LR-N20-0003
LAR S20-01

Salem Generating Station, Units 1 and 2
Renewed Facility Operating License Nos. DPR-70 and DPR-75
NRC Docket Nos. 50-272 and 50-311

Subject: **License Amendment Request to Adopt TSTF-490, "Deletion of E-Bar Definition and Revision to RCS Specific Activity Tech Spec"**

FIGURE 3.4-1

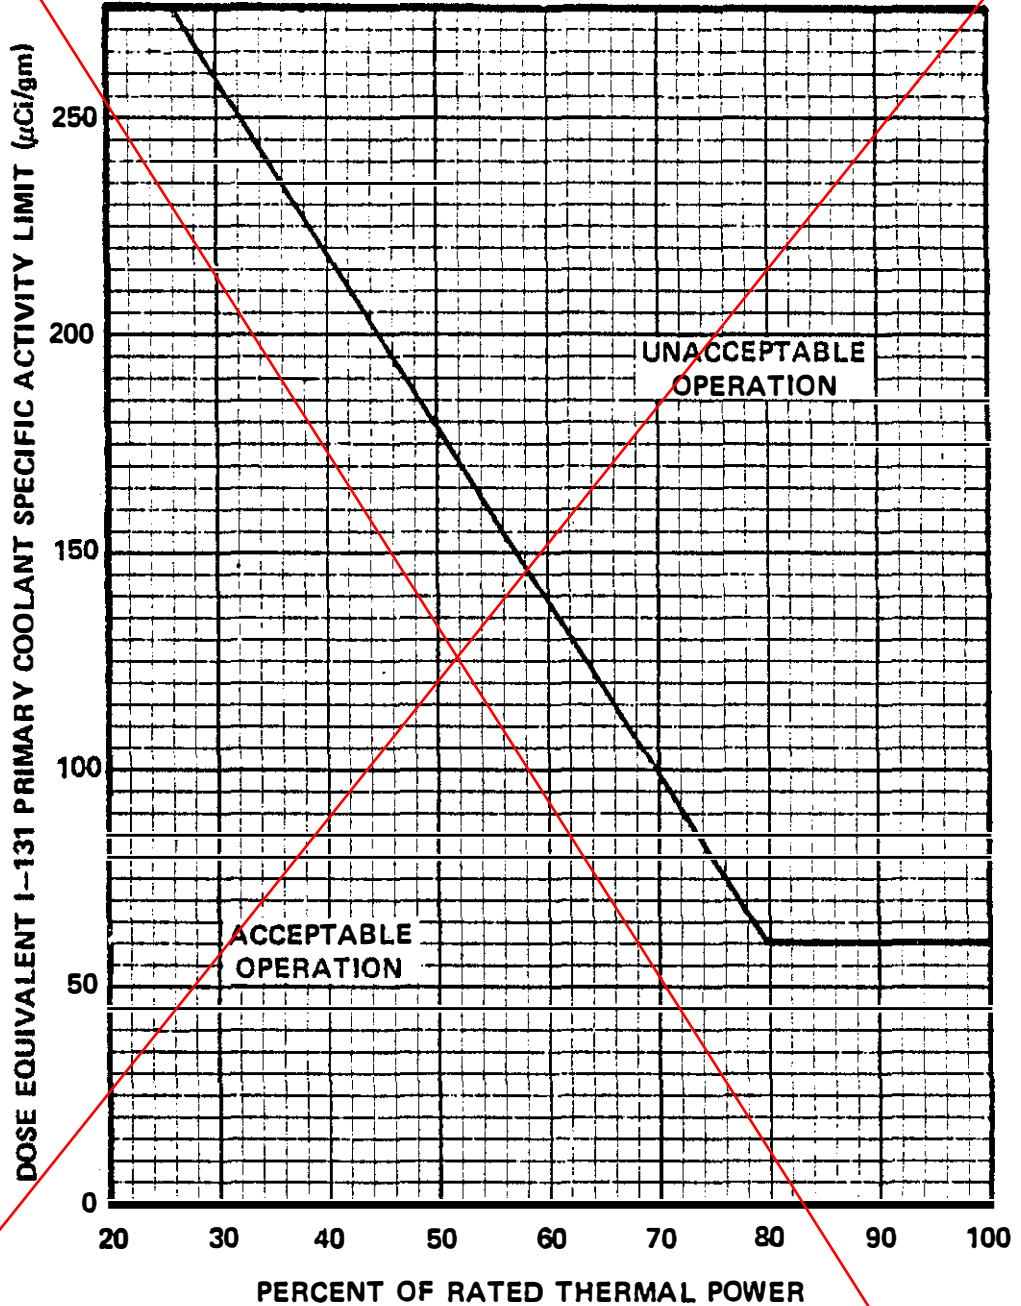
- 2.5 Delete TS Figure 3.4-1, “DOSE EQUIVALENT I-131 Primary Coolant Specific Activity Limit Versus Percent of RATED THERMAL POWER with the Primary Coolant Specific Activity > 1.0 $\mu\text{Ci}/\text{gram}$ Dose Equivalent I-131.”

- The deletion of Figure 3.4-1 is equivalent to the deletion of TSTF-490 Figure 3.4.16-1.
- 2.6 Delete TS Table 4.4-4, “Primary Coolant Specific Activity Sample and Analysis Program.”
